NN OILCONS ARTESIA	ERVATIO	N	• •
	·.	NIN OILCOM	时期IC'		
	UNITED STATES EPARTMENT OF THE INTER	IOR JUL 2	1.5012	FORM OMB N Expires:	APPROVED O. 1004-0135 July 31, 2010
	UREAU OF LAND MANAGEME NOTICES AND REPORTS (ON WELLS OF	CEIVED	 5. Lease Serial No. NMLC028793A 	······································
Do not use this form for proposals to drill or to re-enter an abandoned well. Use form 3160-3 (APD) for such proposals.			6. If Indian, Allottee or Tribe Name		
SUBMIT IN TRIPLICATE - Other instructions on reverse side.				7. If Unit or CA/Agreement, Name and/or No. NMNM88525X

1. Type of Well S Oil Well Gas Well Other			8. Well Name and No. BURCH KEELY UNIT 363		
2. Name of Operator COG OPERATING LLC	OPERATING LLC E-Mail: kcastillo@concho.com			9. API Well No. 30-015-32992-00-S1	
3a. Address 3b. Phone No. (include area code) ONE CONCHO CENTER 600 W ILLINOIS AVENUE 9h: 432-685-4332 MIDLAND, TX 79701 9701				10. Field and Pool, or Exploratory BURCH KEELY-GLORIETA-UPPER YE

Burch Keely Unit 363 30-015-32992 COG Operating, LLC. July 13, 2015 Conditions of Approval

Permanent Abandonment of Production Zone Conditions of Approval

Burch Keely Unit 363

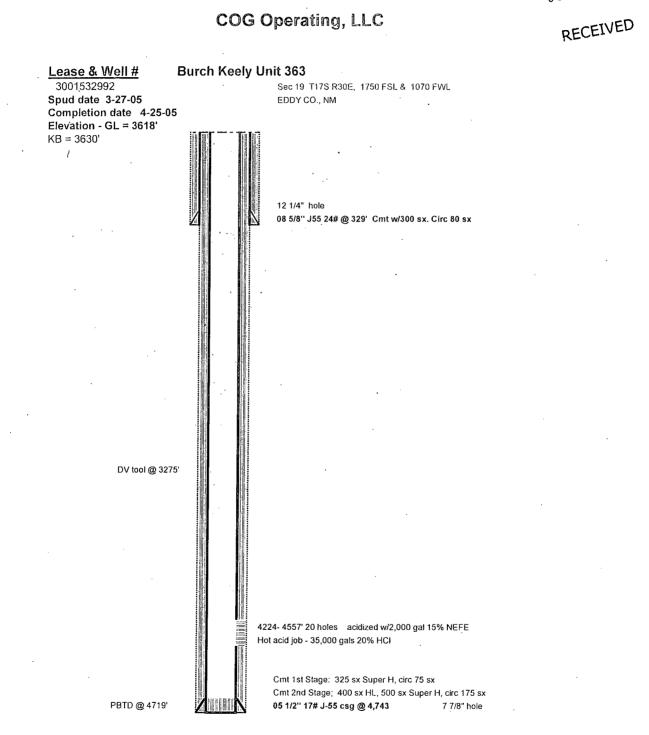
1. Operator shall set a CBP at 4,174'.

2. Operator must submit a sundry to the BLM and State for approval to commingle.

Note: If the operator does not commingle the zones, the operator must submit a sundry to properly abandon the Glorieta formation.

- 3. Must conduct a casing integrity test before perforating and fracturing. Submit results to BLM. The CIT is to be performed on the production casing to max treating pressure. Notify BLM if test fails.
- 4. Before casing or a liner is added or replaced, prior BLM approval of the design is required. Use notice of intent Form 3160-5.
